Service Bulletin

Bulletin No.: PI1203B

Subject: Steam/Vapor Coming from Front Grille or Radiator Area, Engine Runs Rough or Stalls, DTC P0506 Set

Models: 2014 Chevrolet Impala (VIN 1)

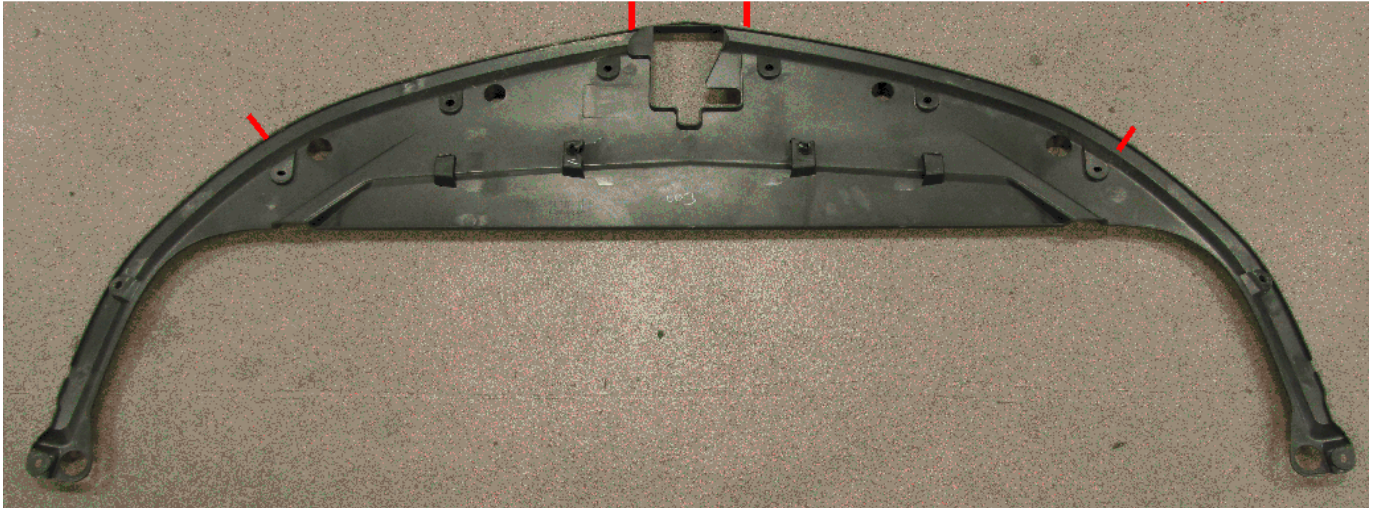
Some customers may comment that after going through a car wash, the vehicle runs rough or engine stalls and may illuminate the MIL and have set DTC P0506.

This condition may be caused by water vapor getting ingested into the induction system through the air intake that is located behind the grille.

Apply BRS tape to the front compartment front sight shield front lip and replace the radiator air upper baffle and deflector following the procedure below.

1. Remove the front compartment front sight shield. Refer to Front Compartment Front Sight Shield Replacement in SI.

2. Cut two pieces of BRS tape 425 mm (17 in) and peel the backing off. Place the adhesive side along the marked area on the front sight shield front lip as shown in the illustration above.
3. Replace the radiator air upper baffle and deflector with the revised part number listed below. Refer to Radiator Air Upper Baffle and Deflector Replacement in SI.
